TO: Hannah Hippely
FROM: Charles M. Buck, P.E., PTOE
DATE: February 13, 2020
SUBJECT: Review of Site Plan
Nine Mile Corner
SP-001117-2019
FHU # 95-190

RE: NINE MILE CORNER – LOWE’S DRAINAGE REVIEW

To: Hannah Hippley
From: David Pasic, P.E., Civil Engineer
Date: February 19, 2020
Subject: **Nine Mile Commerical Site Plan**
CC: Joe Smith, Wendi Palmer, Chad Schroeder, Tyler Burhenn

NINE MILE CORNER - SITE PLAN CONSTRUCTION DOCUMENTS

ISSUE DATE:	11.21.19
PERMIT SET	
ISSUE DATE:	
CONSTRUCTION SET	
ISSUE DATE:	
DRAWING NUMBER:	C5.1

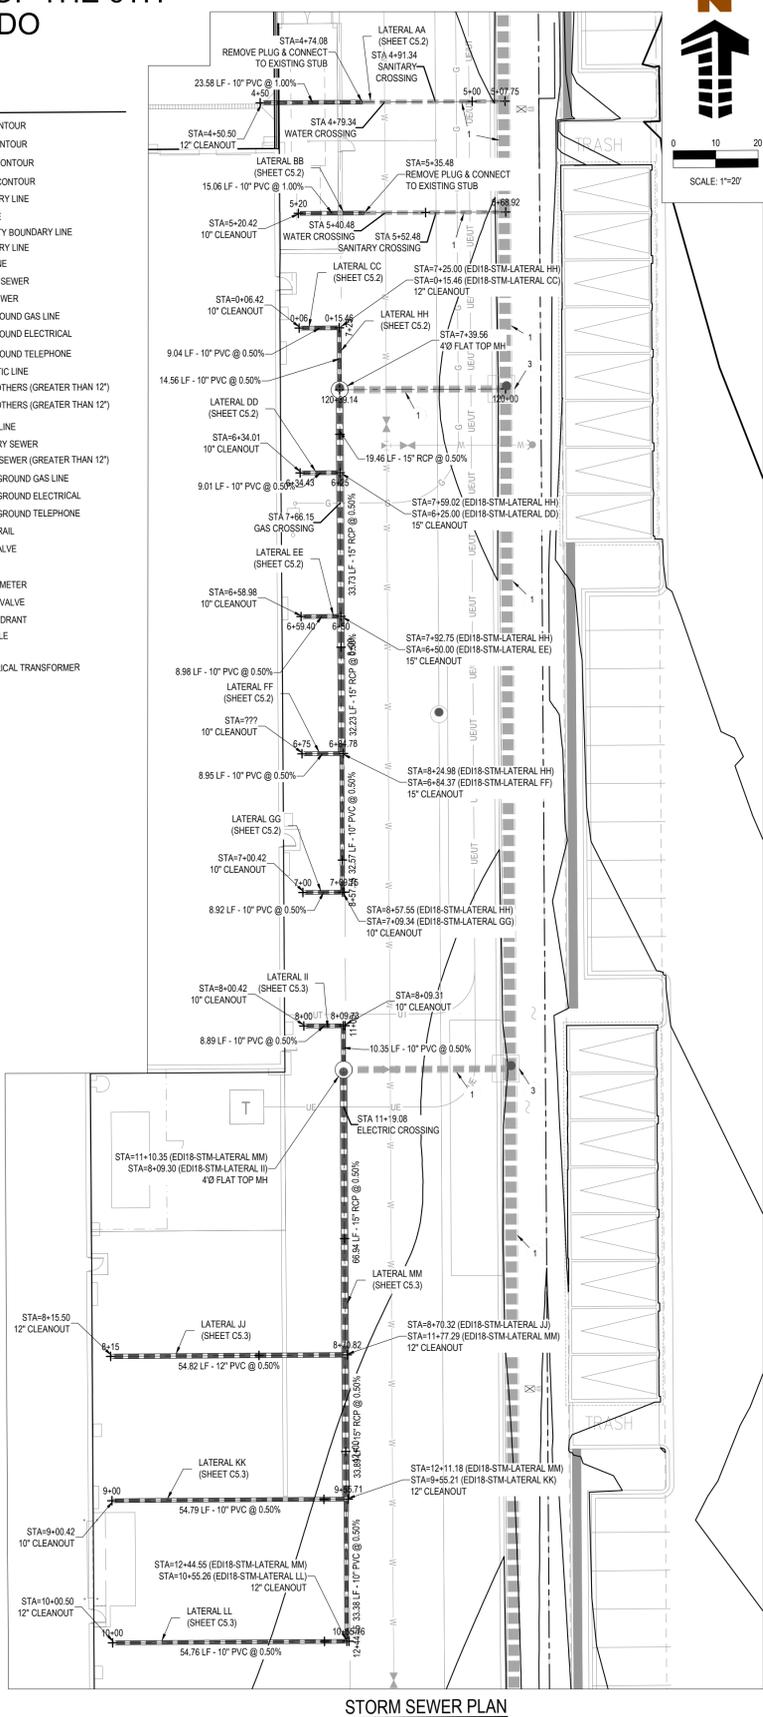
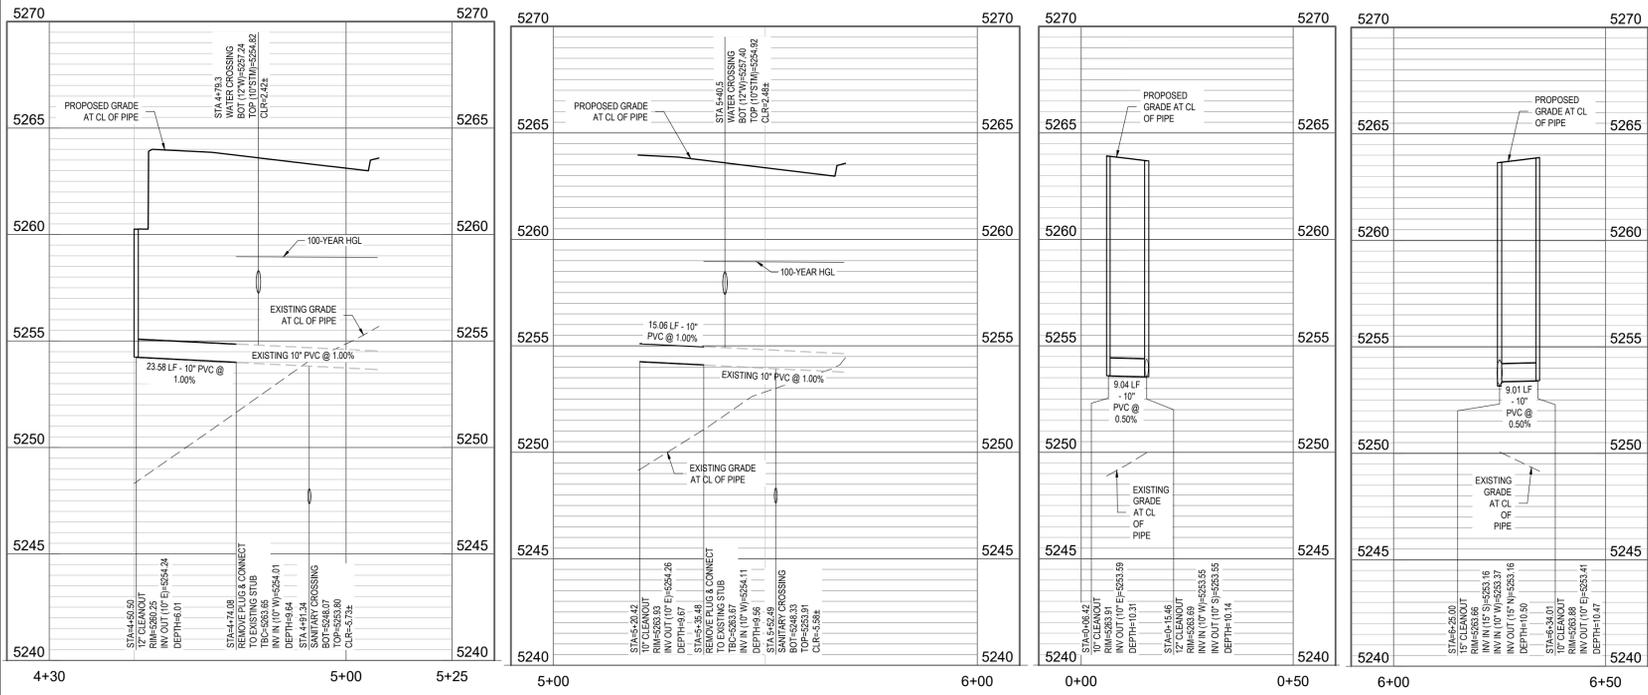
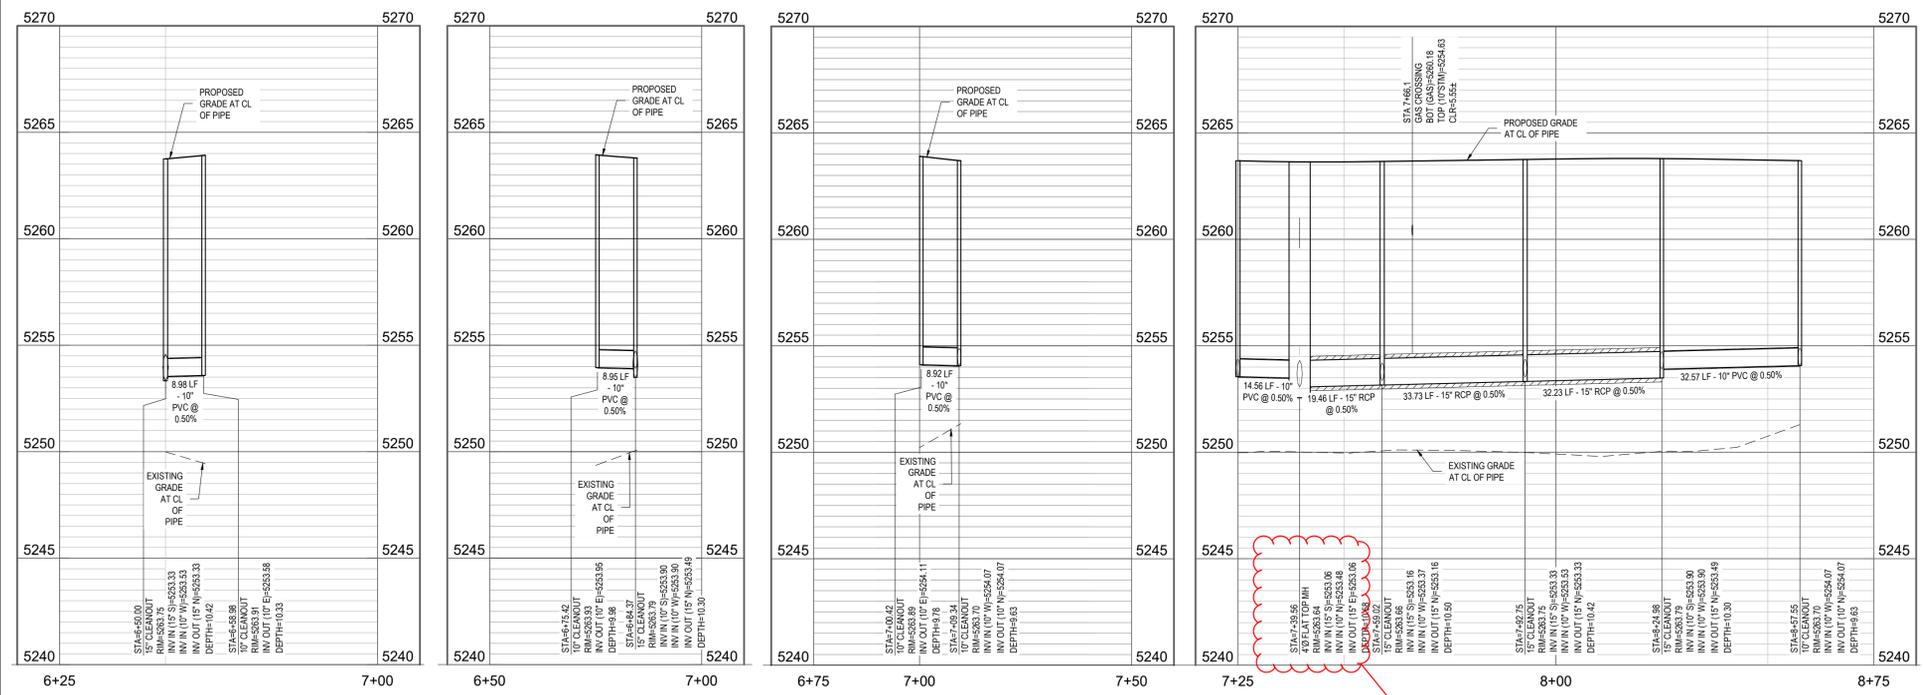
3. On Sheet C5.1, show proposed inlets on all storm pipe profiles.
4. On Sheets C5.1 to C5.3, label the proposed contours on the plan views.
5. On Sheets C5.1 to C5.3 Storm Sewer Plan & Profiles provide hydraulic grade line profiles (StormCAD) for all storm laterals, particularly those on the west side of the Lowe's building that connect from inlets at Design Points 23, 25, 29, and 32 to Storm Line D.

1. On Sheet C5.1, show proposed inlets on all storm pipe profiles.
2. On Sheets C5.1 to C5.3, label the proposed contours on the plan views.
3. On Sheets C5.1 to C5.3 Storm Sewer Plan & Profiles provide hydraulic grade line profiles (StormCAD) for all storm laterals, particularly those on the west side of the Lowe's building that connect from inlets at Design Points 23, 25, 29, and 32 to Storm Line D.

Inv Out Does not match MS Plans

- ii. Irrigation line to the Lowes building shall have irrigation meter.
6. Sheet C5.1
 - a. Provide profiles. Match inverts on minor subdivision.
 - b. Inlet at STA 65+39.87 in the Minor Subdivision is shown as a Type R in the Minor Subdivision Plans but as a Type 16 in the Site Plan Plans.

CRITERIA	ISSUE DATE:	11.21.19
PERMIT SET	ISSUE DATE:	
CONSTRUCTION SET	ISSUE DATE:	
DRAWING NUMBER:		C7.1

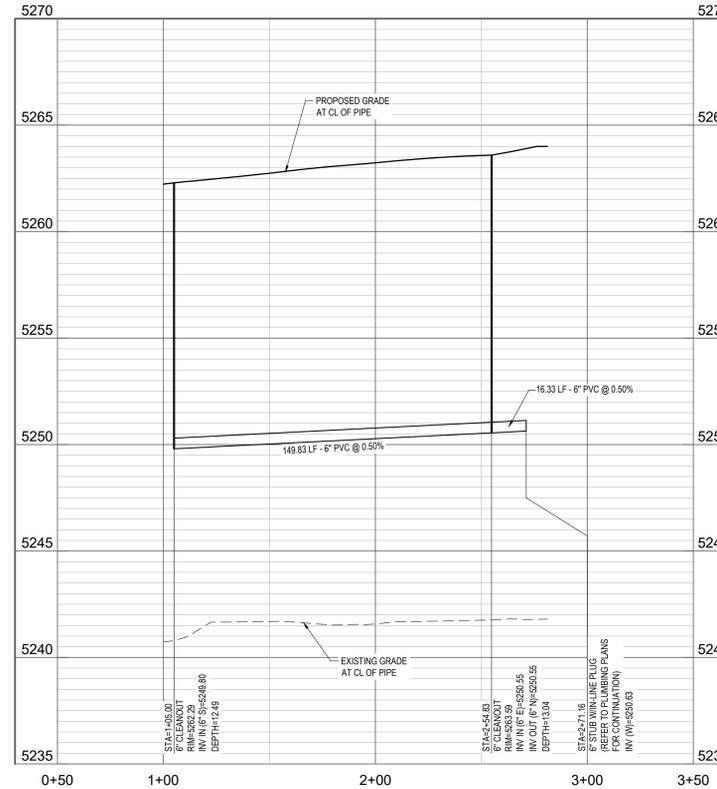
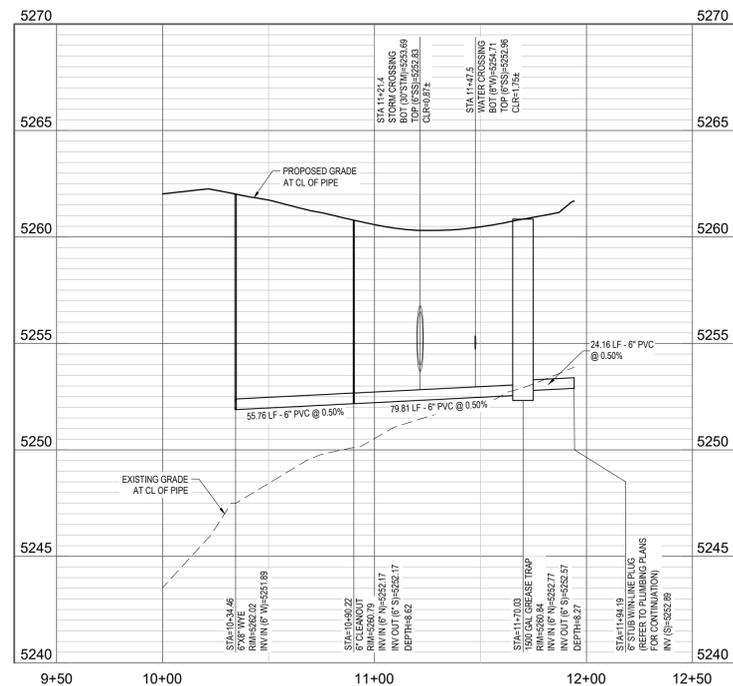
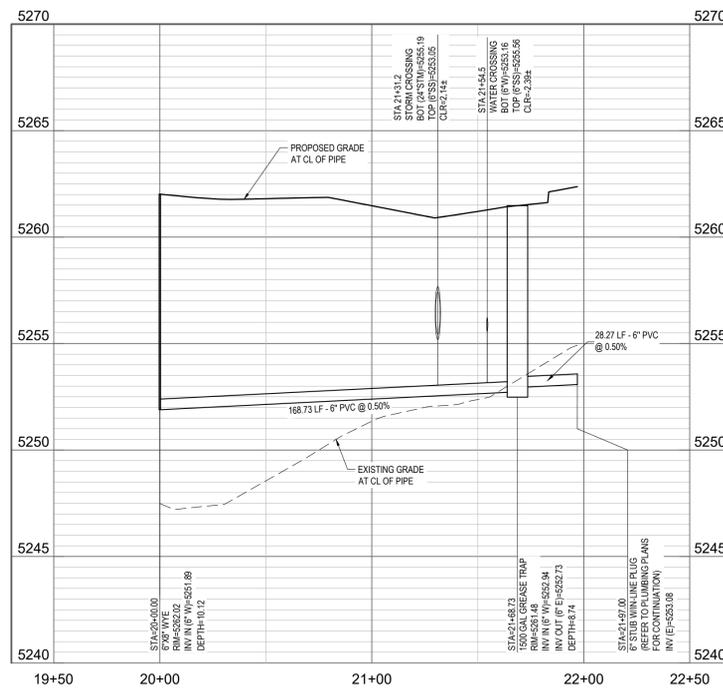
- e. Show invert outs at connection to existing stubs from Minor Subdivision.
- 7. Sheet C7.1
 - a. Main Lines shall be minimum 8" per the Standards and Specifications.
 - b. Differentiate between main lines and service lines.
 - c. Service lines for each of "The Shops" buildings shall have separate sewer taps to the main line.
 - d. On profile from station 20+00 to 21+97, water is shown under sanitary. Water shall be above the sanitary line.
- 8. Sheet IR1.1 and IR1.4
 - a. Irrigation services shall have a separate tap and not be serviced off the water services for the commercial buildings. The reason for this is per the Town Code, the water rates for commercial use and irrigation use are different.
